Subject: Follow-up Status Report on Office of Special Counsel Case DI-10-0680
regarding New York TRACON (N90) & Teterboro Airport (TEB) Use of the
Dalton Departure Procedure

Teterboro (TEB) Airport Runway 19 VFR Departure Procedure with Transition to an IFR Clearance when Newark is landing Runway 22 and Teterboro is departing Rwy 19.

'DALTON DEPARTURE PROCEDURE'

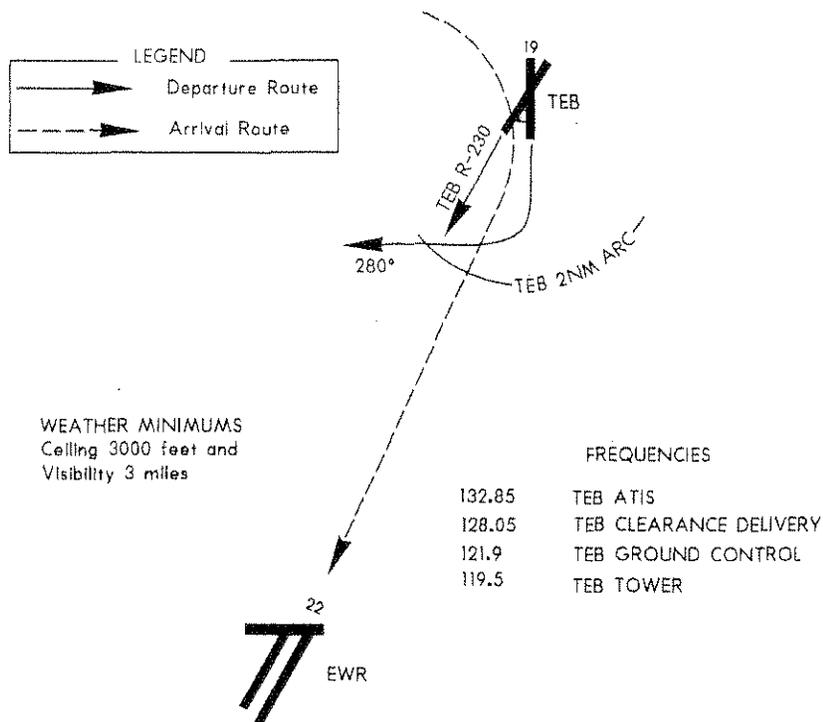
The Dalton Departure Procedure was again changed on April 5, 2012, to delete the requirement to climb to 800' prior to starting the right (west bound) turn. This change enables pilots to complete the turn within 2 nautical miles of the airport pursuant to the June 30, 2011, amendment. (Attached)

AFTER DEPARTURE, TURN RIGHT HEADING 280. COMPLETE THE RIGHT TURN WITHIN 2 DME FROM TEB. MAINTAIN VFR AT OR BELOW 1300 FT; DO NOT EXCEED 190 KNOTS. IF UNABLE, ADVISE.

EXPECT A CLIMB CLEARANCE AFTER CROSSING THE TEB R-230. THE CLIMB CLEARANCE CONSTITUTES IFR ACTIVATION AND PILOTS ARE EXPECTED TO RESUME NORMAL AIRSPEED. EXPECT CONTROL INSTRUCTION TO A DEPARTURE FIX AS DESCRIBED IN THE PUBLISHED TEB STANDARD INSTRUMENT DEPARTURE.

NOTE: CAUTION WAKE TURBULENCE. NO WAKE TURBULENCE SEPARATION IS PROVIDED FROM NEWARK RWY 22 ARRIVAL TRAFFIC DESCENDING OVER TEB FROM 3000' TO 1800'.

IN THE EVENT OF LOST COMMUNICATION PRIOR TO IFR ACTIVATION, SQUAWK 7600. MAINTAIN VFR.
